Millstone Power Station, Unit No. 2  
Response to Request for Additional Information on RR-89-48 for the  
Nozzle Inspection Ultrasonic Test Coverage Requirements in Order EA-03-009

Westinghouse Non-Proprietary Class 3  
RAI Responses to Millstone Unit 2 Relaxation Request  
WCAP-15813-NP, Revision 0

**RAI Responses to Millstone Unit 2 Relaxation Request**  
**WCAP-15813-NP, Rev. 0**

### *Early 1990's Model*

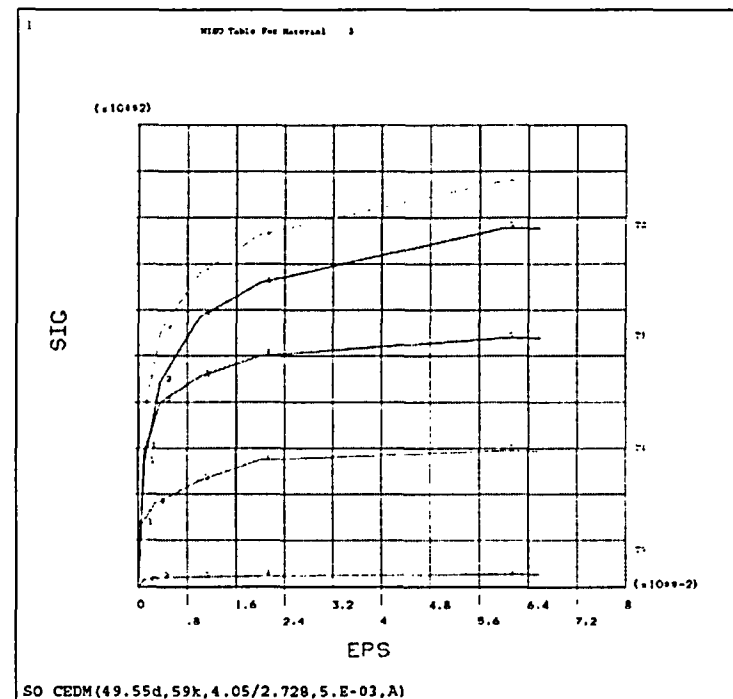
You mentioned in Section 5-3 that the vessel to penetration nozzle weld was simulated with two weld passes. Please provide the actual number of weld passes for fabricating the vessel to penetration nozzle weld and justify quantitatively that using two weld passes in your FEM modeling would adequately represent actual residual stresses.

- DEI's CRDM welding residual stress model was originally designed in the early 1990's for the purpose of simulating stresses on the nozzle ID surface
- Model made use of multilinear isotropic work hardening curves with similar shapes to those for Alloy 600 base material
- Yield strength as a function of temperature was derived from 0.2% offset yield data in ASME Code
